Lift and Escalator Industry Association

STANNAH STAIRLIFT, SAFETY BULLETIN

STAIRLIFT SAFETY BULLETIN

Carriage Modification

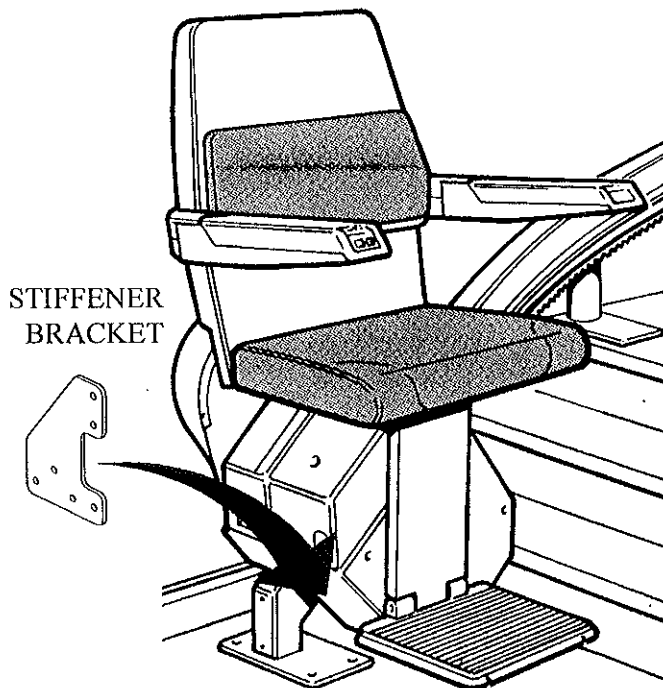
Effective to all Model 209's manufactured from April 1982 to May 1983.

The carriage and chair can become loose on the rail under extreme circumstances of overload, abuse or excessive use. This is due to fatigue and has occurred on one stairlift permanently in use since 1982.

Stannah are recommending inspection of all Model 209 stairlifts manufactured between these dates and stiffener brackets fitted to the carriage where appropriate.

Automatic Platform Modification

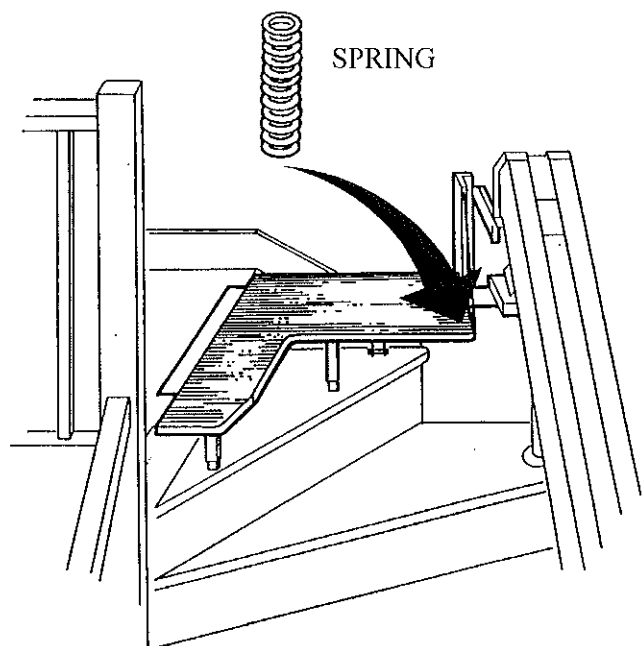
Effective to all straight Models 230 manufactured from December 1995 to June 1998.

The wire cable controlling the lowering of the platform can be prone to wear thus causing the platform to lower in an uncontrolled manner.

Stannah are recommending the replacement of this cable at each service and also the replacement of a small spring.

Stannah will supply all the parts required together with full instructions. The modification should be fitted to all stairlifts which could be prone to this problem.

Swivel Seat Safety Modification

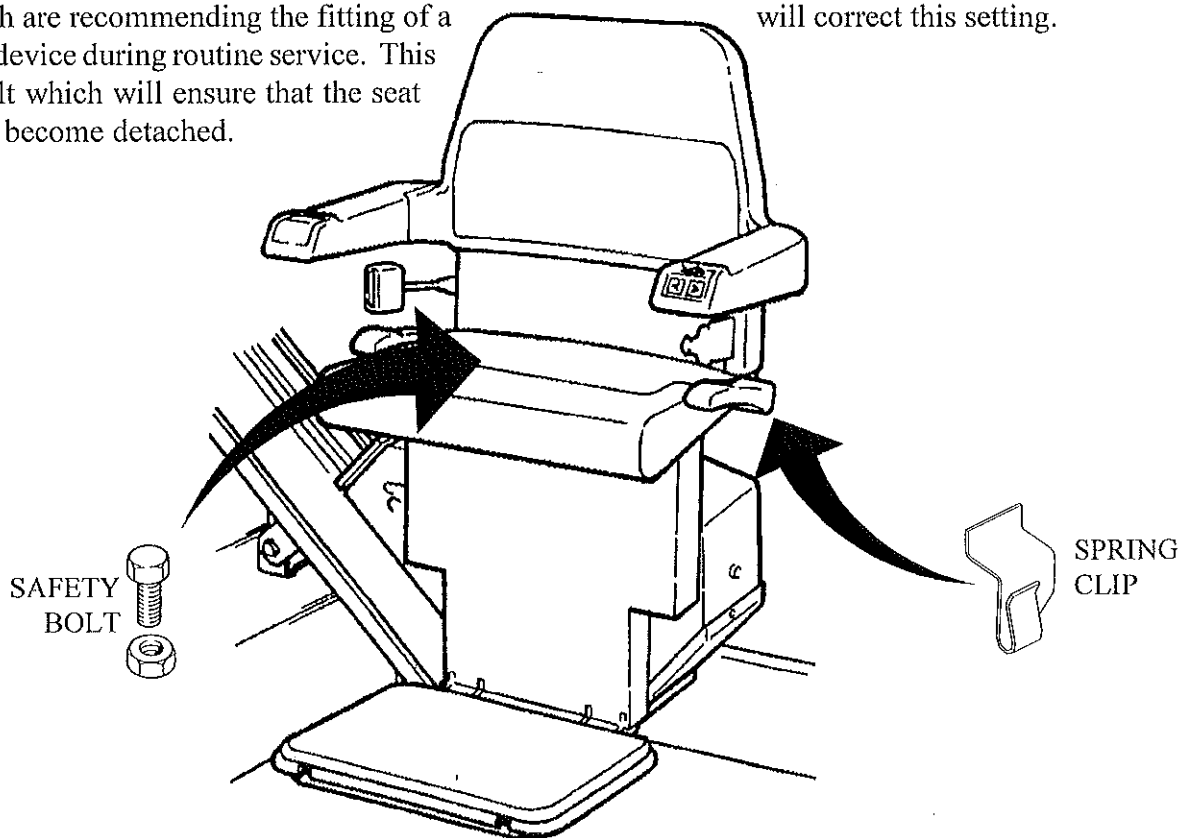
Effective to all straight Models 225 and 230 manufactured from March 1991 to September 1998.

The swivel seat can become detached from the carriage under extreme circumstances of overload, abuse or excessive use. This is due to fatigue and has occurred in a few instances with stairlifts permanently in use since 1993.

Stannah are recommending the fitting of a safety device during routine service. This is a bolt which will ensure that the seat cannot become detached.
